UNITED STATES PATENT AND TRADEMARK OFFICE

APPLICATION NO.	FILING DATE	FIRST NAMED INVENTOR	ATTORNEY DOCKET NO.	CONFIRMATION NO.
09/940,949	08/28/2001	Luc Tripod	PU010180	5192

Office Action Summary	Application No.	Applicant(s)
	09/940,949	TRIPOD, LUC
	Examiner	Art Unit
	James R. Harvey	2833

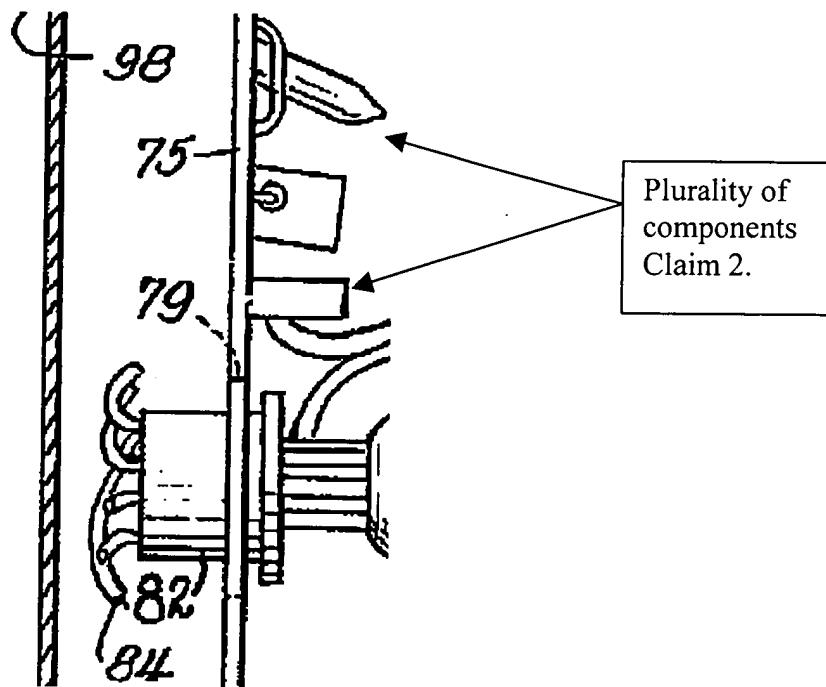
-- In reference to claim 1, Johnson shows (cover sheet) an arrangement for coupling a cathode ray tube (CRT) (near 39) to a socket 82 which is mounted on a circuit board 75 the CRT having a funnel portion (near 16) and a neck portion (near 39) containing an electron gun, the circuit board 75 being positioned with a first side facing the funnel portion and a second side facing away from the funnel portion, the socket 82 having terminals which engage corresponding

terminals on the CRT, the socket terminals being positioned on the second side of the circuit board 75.

However, Johnson does not show terminals being positioned along the side of the neck portion of the CRT.

-- In reference to claim 2, Johnson shows the circuit board 75 has a plurality of components mounted thereon, none of the components extending away from the funnel portion further than the rearmost portion of the socket (see examiner's detail of (cover sheet)).

-- In reference to claim 4, Johnson shows the socket 82 has a back cover which abuts the end of the neck portion. The meaning of "abuts" is seen to define to lie adjacent. The American Heritage Dictionary of the English Language, Third Edition copyright 1992 by Houghton Mifflin Company. Electronic version licensed from IINSO Corporation. Copy attached.
